## PRODUCT/PROCESS CHANGE NOTICE (PCN)

<b>PCN #:</b> <b>A1804-01</b> <b>DATE:</b> <b>18-Apr-2018</b> <b>Product Affected:</b> TSE2004GB2C0NCG TSE2004GB2C0NCG8  <b>Date Effective:</b> <b>18-Jul-2018</b>	<b>MEANS OF DISTINGUISHING CHANGED DEVICES:</b> <input type="checkbox"/> Product Mark <input type="checkbox"/> Back Mark            Assembly lot# prefix: <input type="checkbox"/> Date Code            "TF" denote TFME, China <input checked="" type="checkbox"/> Other                    "HT" denote HTC, China
--	---

### ATTACHMENT 1 - PCN # : A1804-01

**PCN Type:** Manufacturing Site - Alternate Assembly, Test & Backend Location

Table 1: Carrier Tape Comparisons

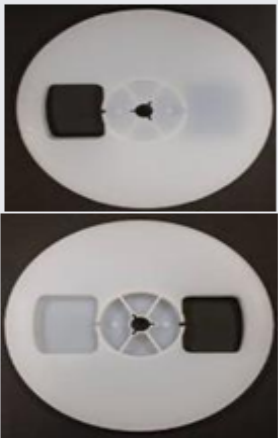
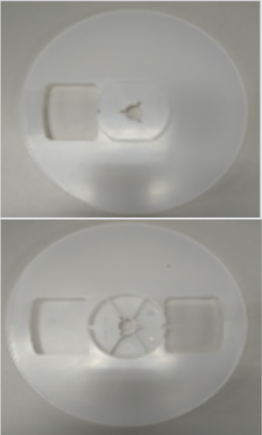
Carsem, Malaysia	TFME, China
<b>Part Number</b>	C-PAK BD0200x0300	ECA1941-PS-BLK-520
<b>Ao</b>	2.3+0.1mm	2.3+0.05mm
<b>Bo</b>	3.2+0.1mm	3.2+0.05mm
<b>Ko</b>	1.0+0.1mm	1.0+0.05mm
<b>P</b>	4.0+0.1mm	4.0+0.1mm
<b>W</b>	8.0+0.3mm	8.0+0.2/-0.1mm
<b>Drawing</b>	Refer Page 7	Refer Page 8
<b>Snapshot</b>

Table 3: Carrier Tape Comparisons

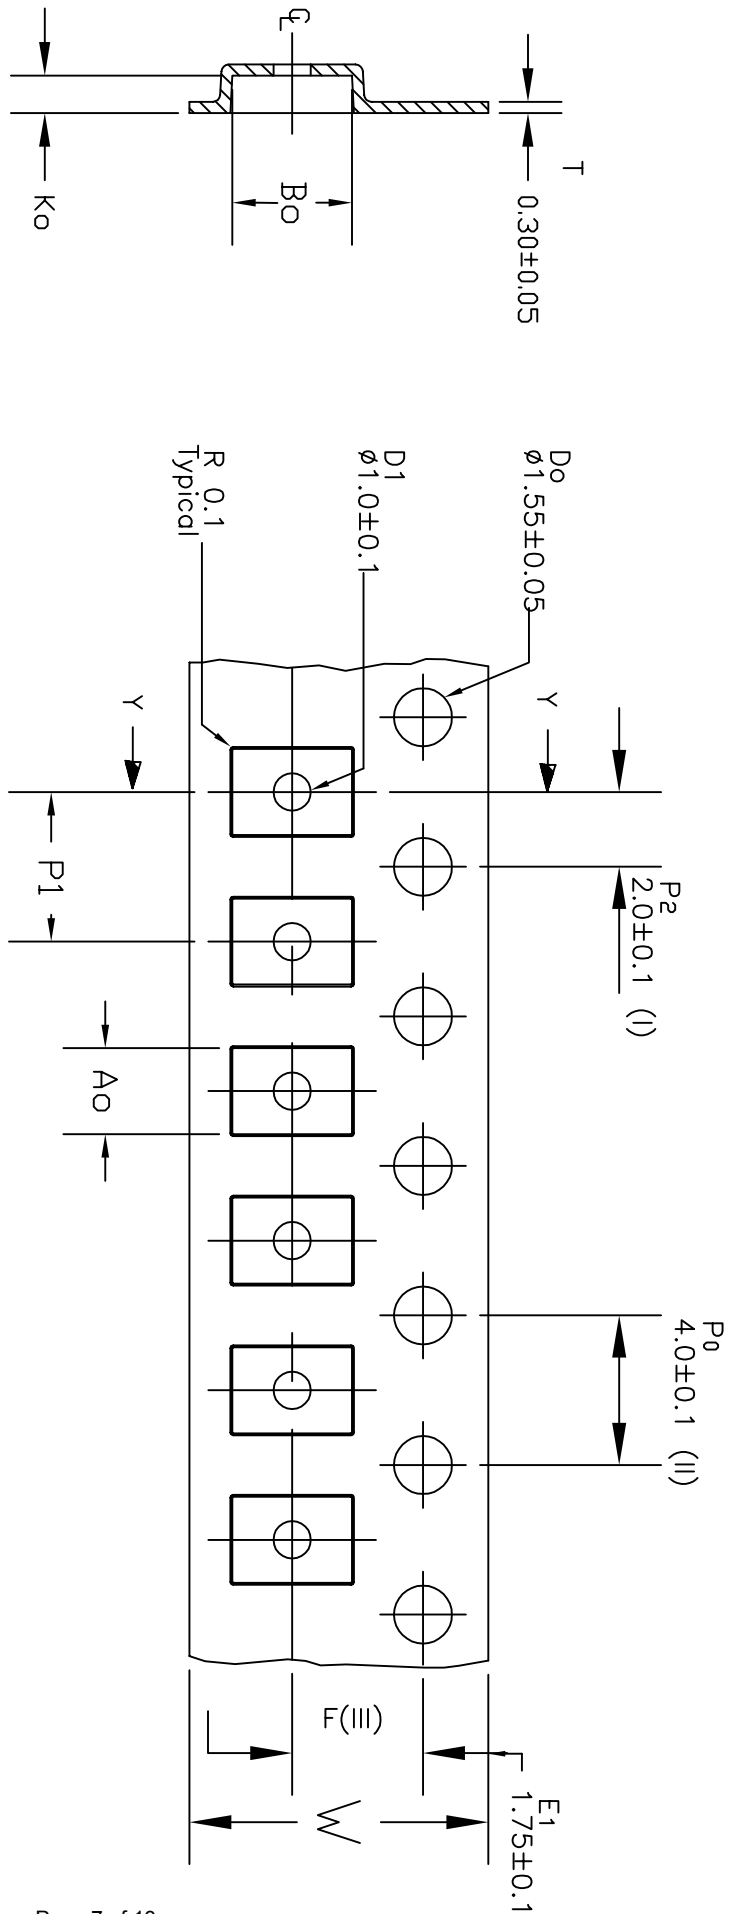
Carsem, Malaysia	HTC, China
<b>Part Number</b>	C-PAK BD0200x0300	ECA1941-PS-BLK-520
<b>Ao</b>	2.3+0.1mm	2.3+0.05mm
<b>Bo</b>	3.2+0.1mm	3.2+0.05mm
<b>Ko</b>	1.0+0.1mm	1.0+0.05mm
<b>P</b>	4.0+0.1mm	4.0+0.1mm
<b>W</b>	8.0+0.3mm	8.0+0.2/-0.1mm
<b>Drawing</b>	Refer Page 7	Refer Page 12
<b>Snapshot</b>

TFME Carrier Tape

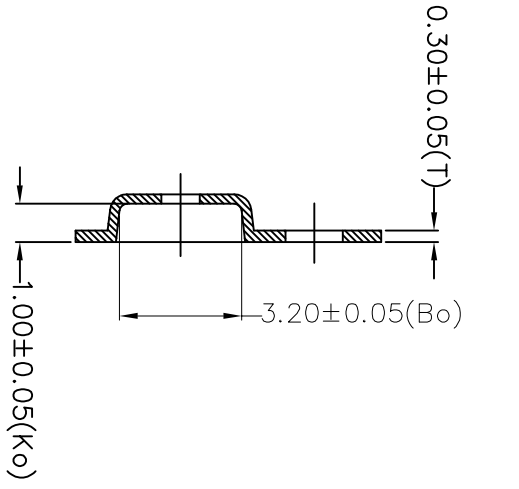
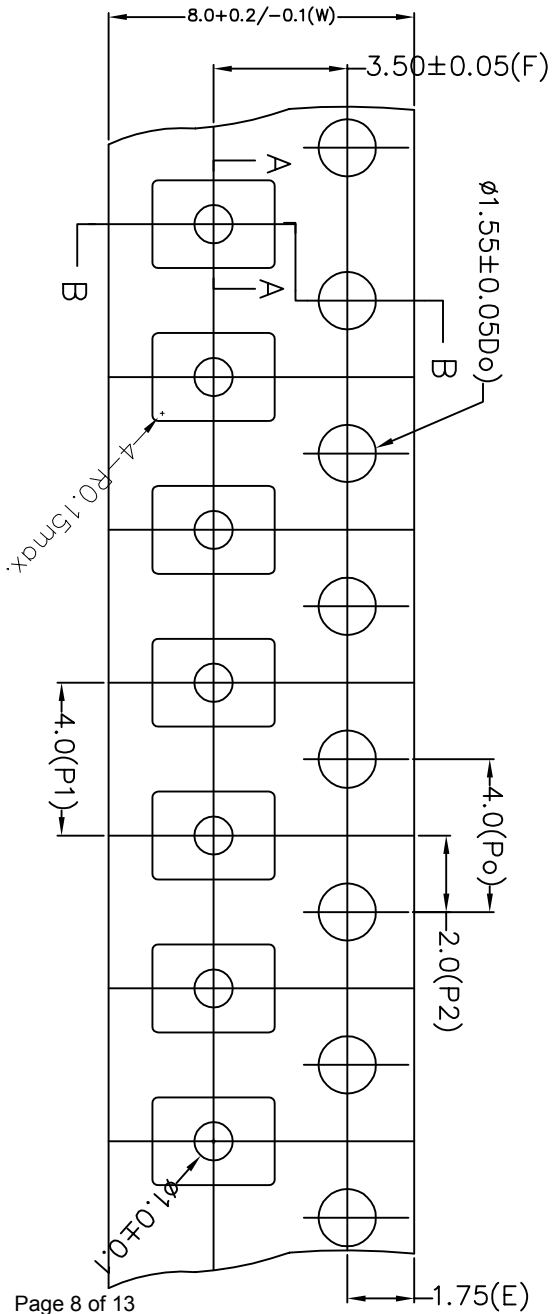
The Backend process is standardized between the alternate sites. The carrier tape and plastic reel used in the alternate sites are with the same dimensions as used in Carsem Malaysia. There is no change to form, fit and functions.

TFME Reel

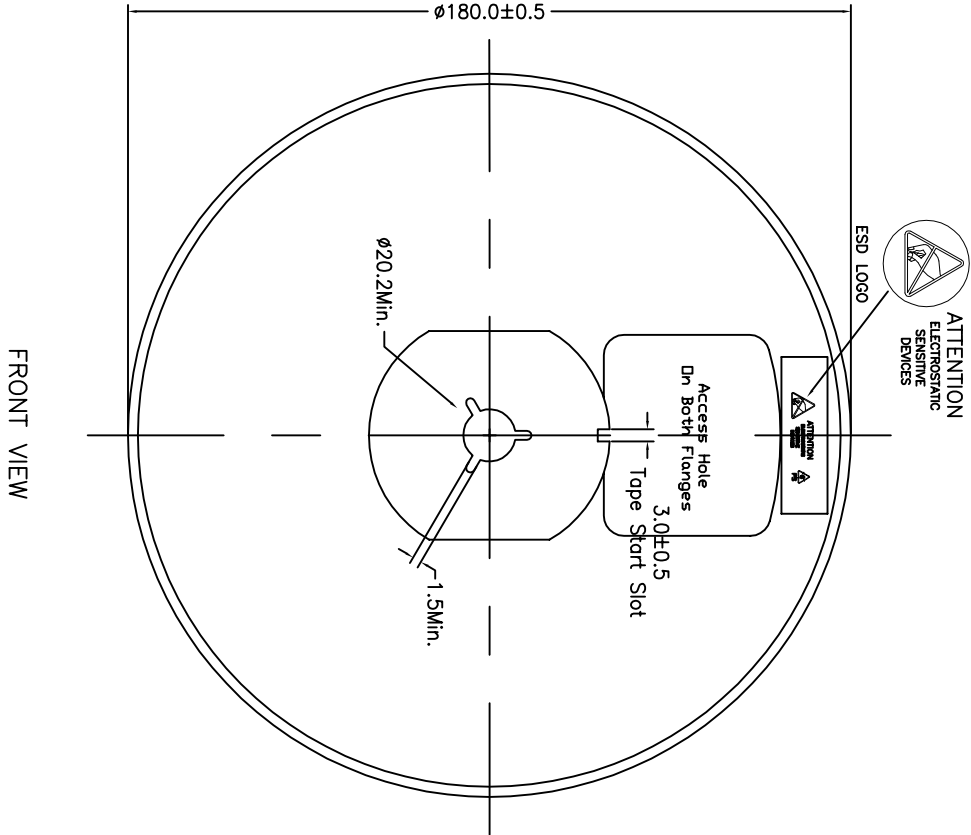
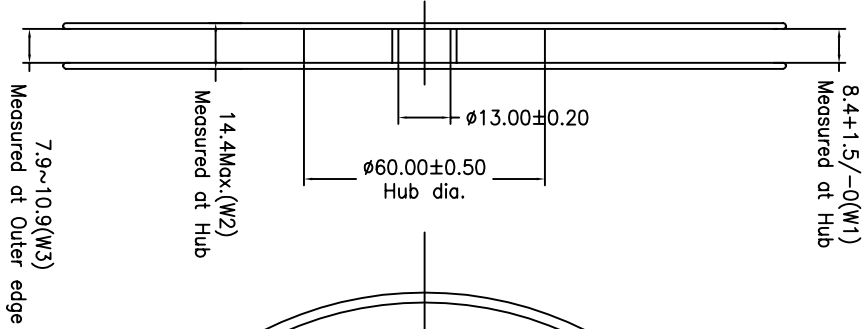
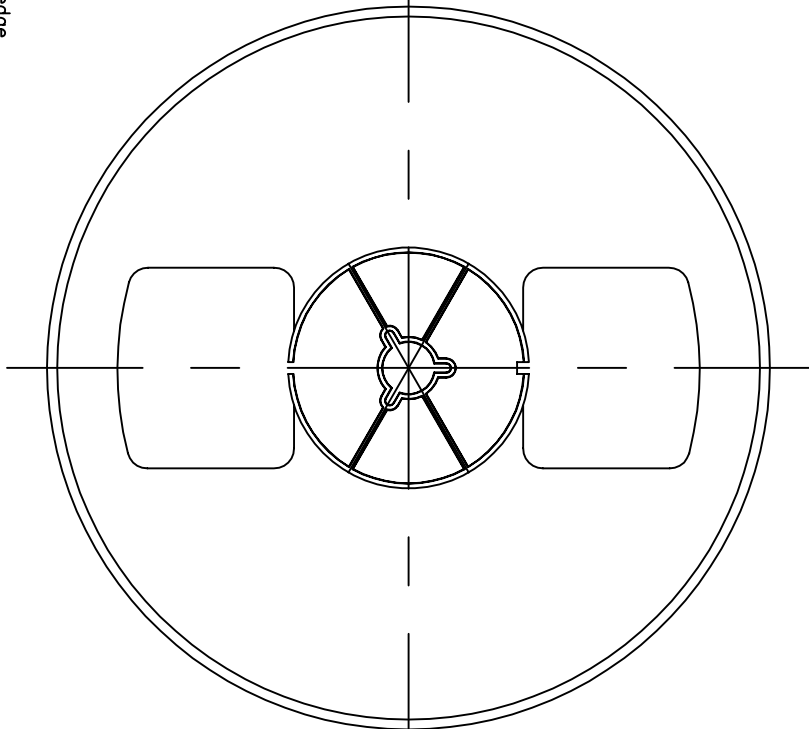
Carsem, Malaysia	TFME, China
<b>Part Number</b>	NEWTECH P9-065-000 White	E-PAK eRL0126-T08-A47-TRL
<b>Reel Dia</b>	7"	7"
<b>Hub Dia</b>	2"	2"
<b>Drawing</b>	Refer Page 9, 10	Refer Page 11
<b>Snapshot</b>

TITLE: 7" PLASTIC REEL FOR 8 MM		SCALE N/A
STOCK NO. N/A	DRAWING NO. MSC-8402-A	REV 00
DO NOT SCALE DRAWING		SHEET 1 OF 1

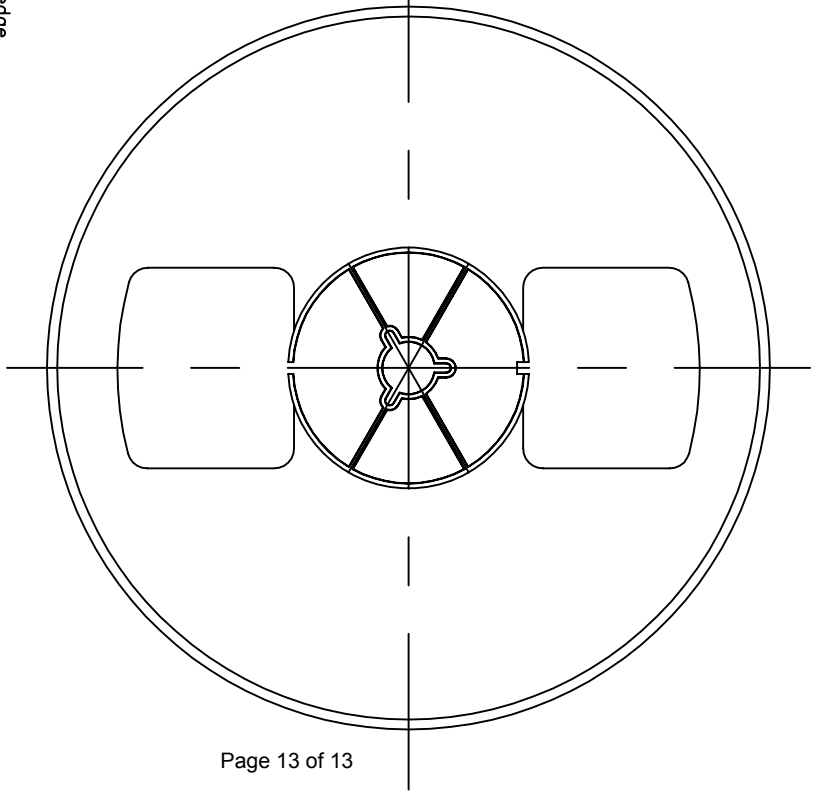
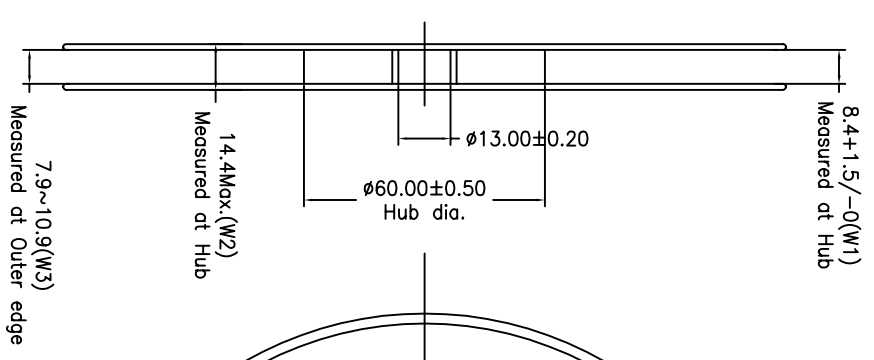
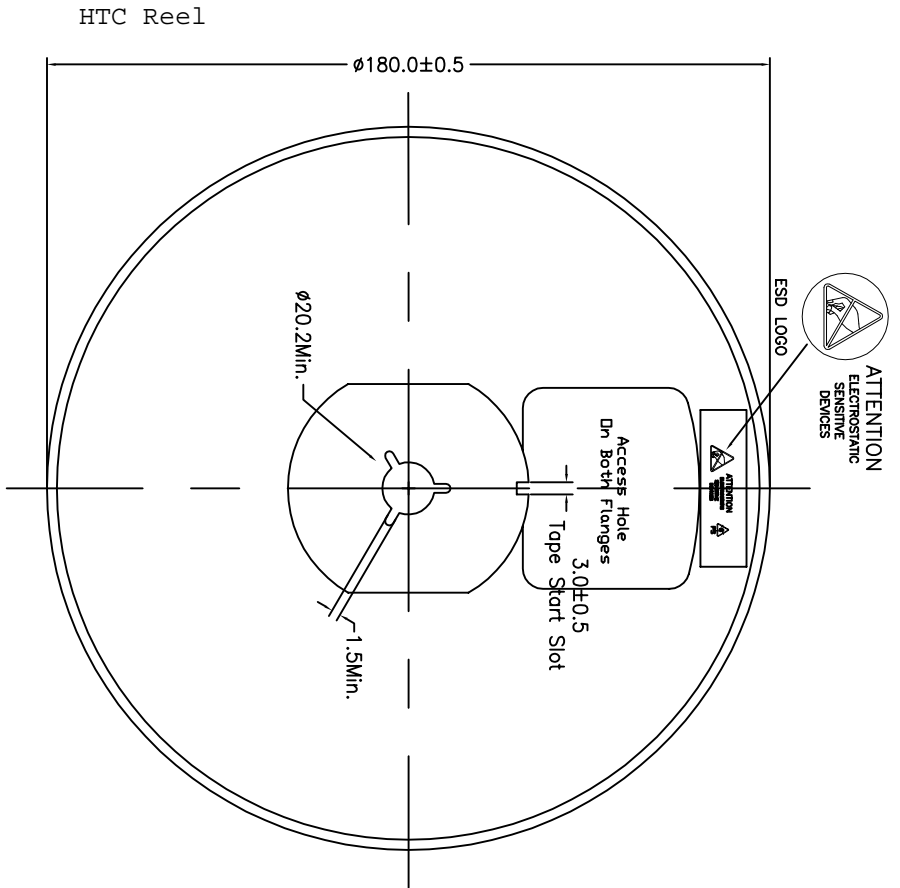
Carsem, Malaysia	HTC, China
<b>Part Number</b>	NEWTECH P9-065-000 White	E-PAK eRL0126-T08-A47-TRL
<b>Reel Dia</b>	7"	7"
<b>Hub Dia</b>	2"	2"
<b>Drawing</b>	Refer Page 9, 10	Refer Page 13
<b>Snapshot</b>
